1 DREDGING PLAN

City of Valdez
NEW HARBOR
INNER HARBOR FACILITIES

2 DF 2
C3.0

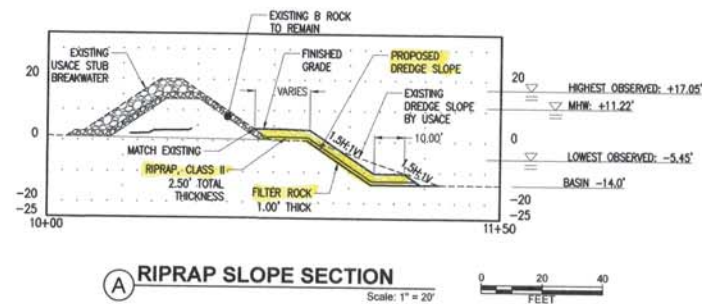
Added filter rock and riprap
